City Planning Commission Regular Meeting
October 24, 2013, 5:00 PM
Committee of the Whole Room
13th Floor – Coleman A. Young Municipal Center
Woodward at Jefferson
(use Randolph Street entrance after 5:30 PM)

- A. **SPECIAL DEVELOPMENT DISTRICT REVIEW** - Consideration of a PCA (Public Center Adjacent) zoning district review of proposed modifications to the First National Bank Building, 600 Woodward Ave., to facilitate the development of a Papa Joe's market on the ground floor of the historic building along the Cadillac Square frontage. (**MT**) (**ACTION REQUESTED**) *20 mins.*

RE: **PCA (Public Center Adjacent) review of Exterior changes to the First National Building, located at 660 Woodward Avenue, for Papa Joe's Market**

5. PROPOSED DEEP PLAN
 DATE: 10/11/17

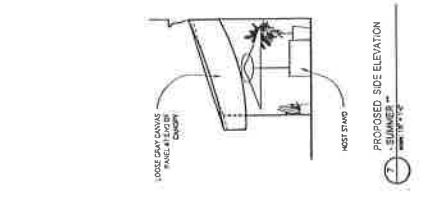
(4) Vehicular and pedestrian circulation facilities should be adequately designed to meet expected demands; disruption of traffic flow in surrounding areas should be minimized; truck traffic should be carefully planned and controlled; *The width of the platform must be narrow enough to leave six (6) feet between it and all obstructions in the sidewalk, such as sign posts, light poles, etc to allow for pedestrian circulation. It appears that it will have to be narrowed slightly.*

3. VALANCE SIGN ON TEMPORARY CANOPY ELEVATION (8 LOCATIONS TOTAL)
Scale: 3/4" = 1'-0"

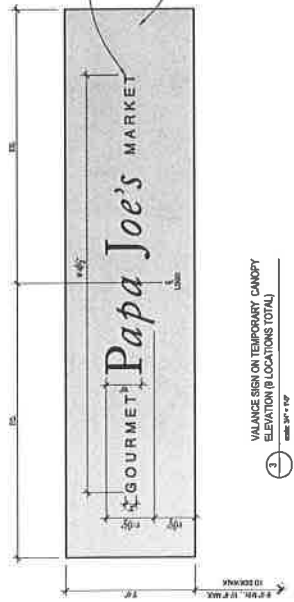
(11) Signage and graphics should be tastefully designed to be visually appealing and in character with surrounding development; they should provide needed information, direction and orientation in a clear and concise manner; *While the proposed signage is tasteful, staff questions the need for a sign on every panel of the proposed awning.*

CPC staff has completed its review of the proposed alterations, as has the Planning and Development Department staff. We find that the exterior changes would be in keeping with the spirit and intent of the PCA zoning district. Therefore, staff recommends approval of the location and design of the proposed changes, with the condition that the number of signs on the awning be reduced to a number that the CPC feels is reasonable and appropriate.
